DSAX93204A-03

S E R V I C E N O T E

DSAX93204A 32GHz Digitizing Oscilloscope

Front panel connector may not offer a good ground connection for probes

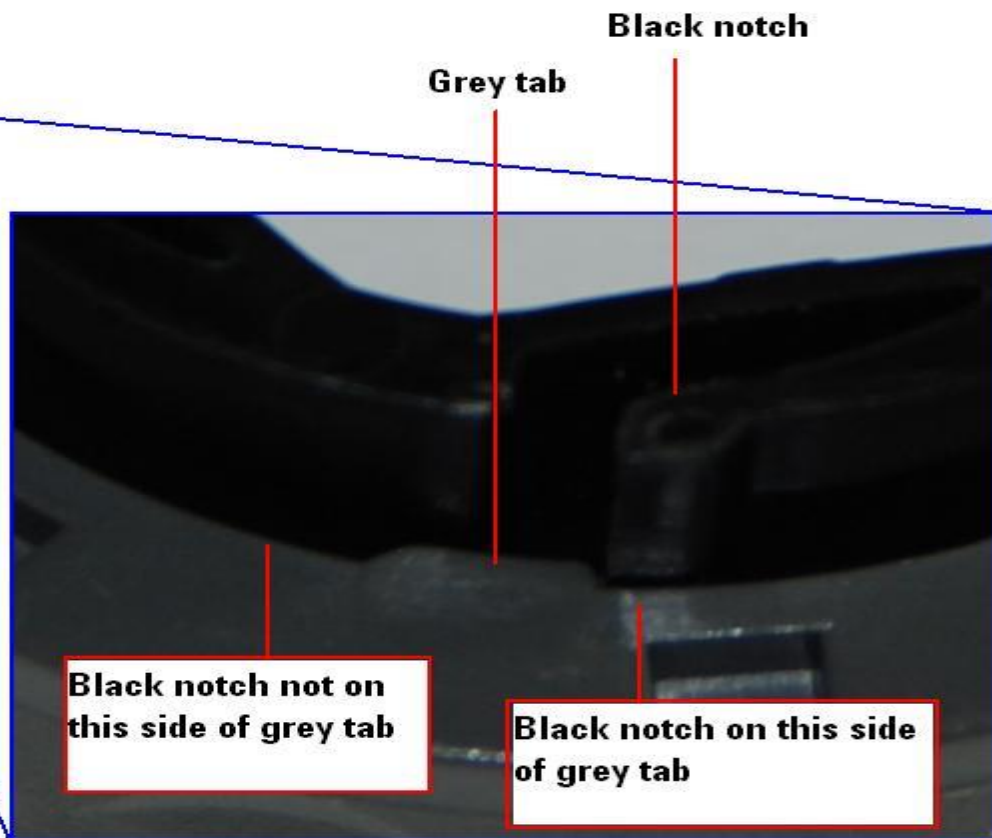
1. Find a soft strap or something similar to remove the clutch from the front panel connector. Do not use anything metallic to pry the clutch away from the front panel. You will scratch and damage the front panel.

2. Put the soft strap or string behind the gray outer clutch and carefully work it around the outer clutch.
